ABALONE COVE WELL CONVERSION PROJECT

RESPONSE TO COMMENTS AND FINAL ENVIRONMENTAL IMPACT REPORT

CITY OF RANCHO PALOS VERDES

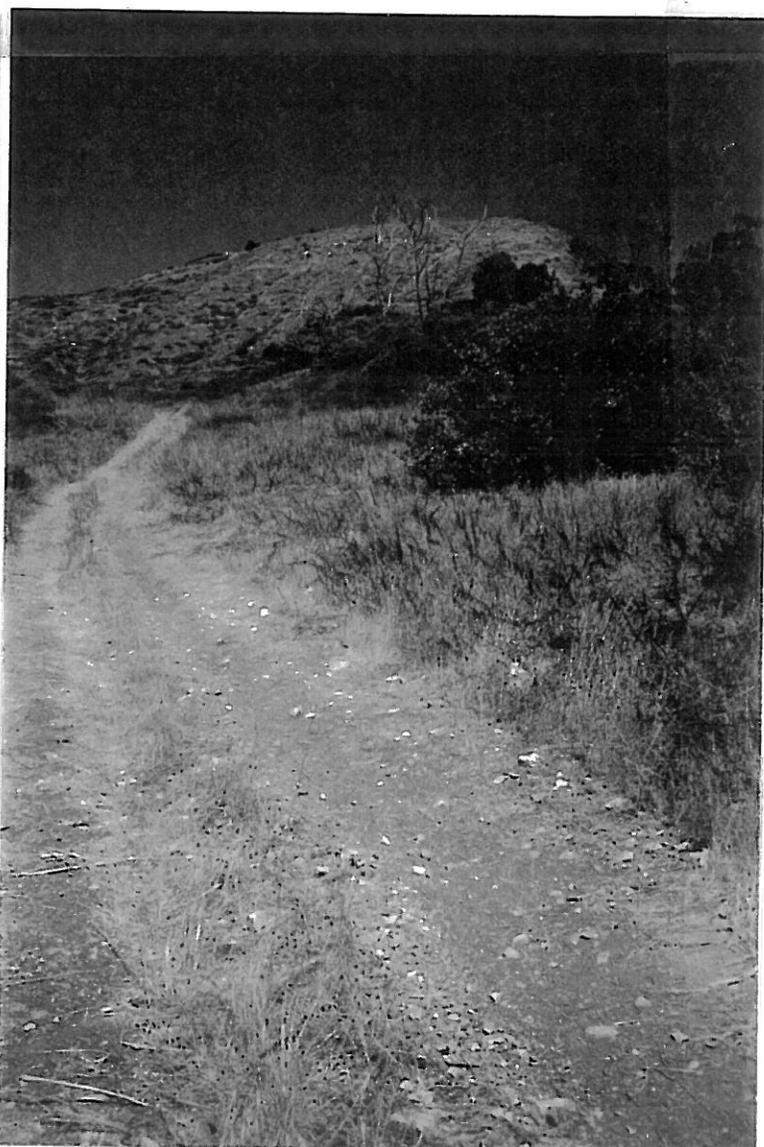
THE ACCESS ROAD HAS SUFFERED COMPACTION OF AT LEAST 10,000 SQUARE FEET OF ENVIRONMENTALLY SENSITIVE MOUNTAIN SIDE WATERSHED AND GNATCATCHER HABITAT BY THE ILLEGAL USE OF VEHICLES ON A TRAIL BY THE CITY/RDA/EIR STAFF WHILE TRYING TO FIGURE OUT IF THE AREA WAS ENVIRONMENTALLY SENSITIVE. ALL ACCESS TO THIS AREA SHOULD BE LIMITED TO WALKING IN TO THE SITE.

LOCATION OF POWER POLES AND
OVERHEAD ELECTRICAL LINES

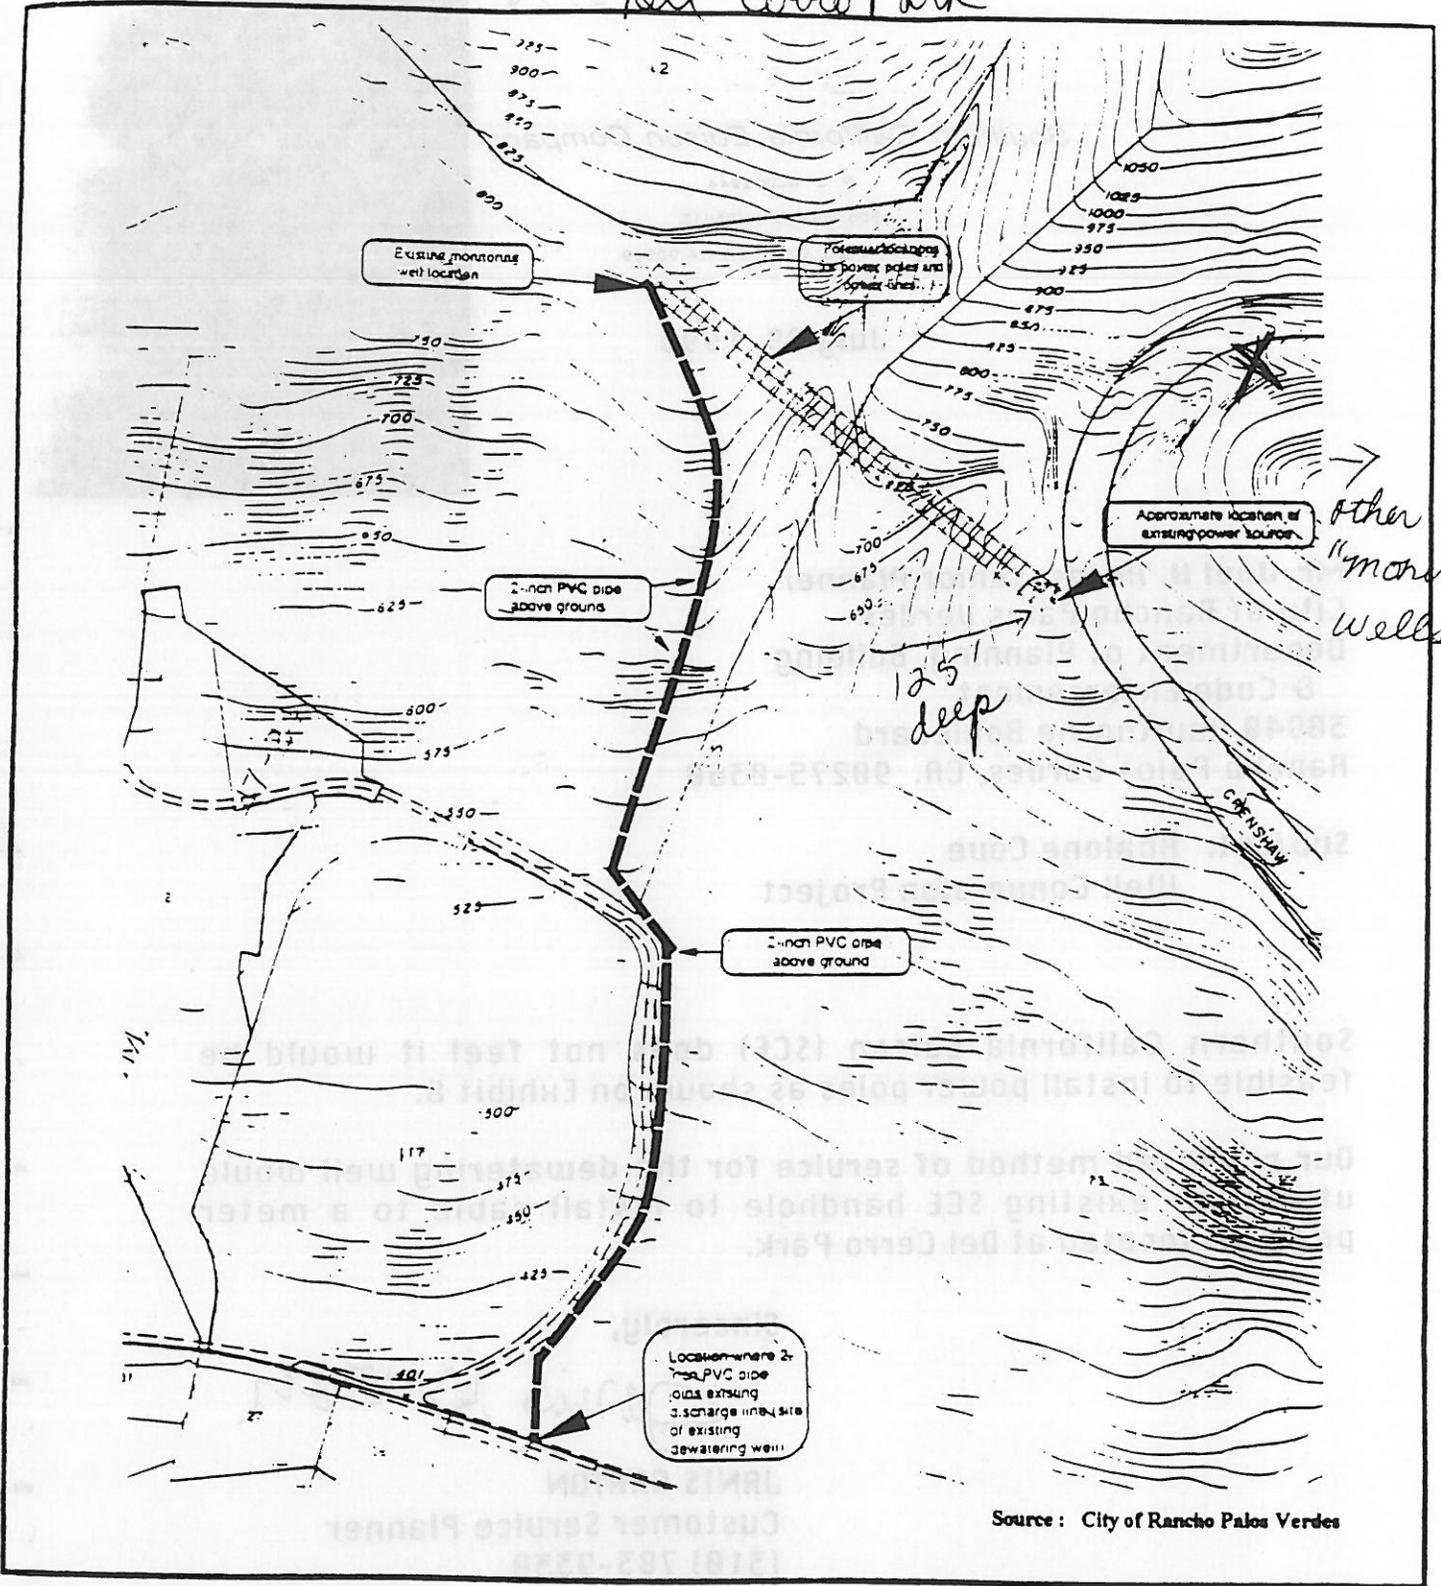
COMMENT KS #53	RESPONSE KS #53
Exhibit 10. WITH THE GRIDS, I CAN NOT SEE WHERE THE POLES ARE GOING NOR CAN I FIGURE OUT WHERE THE LINE IS?	Please refer to Response to Comment KS #33 related to the location of power poles and lines.

Exhibit 10. WITH THE GRIDS, I CAN NOT SEE WHERE THE POLES ARE GOING NOR CAN I FIGURE OUT WHERE THE LINE IS?
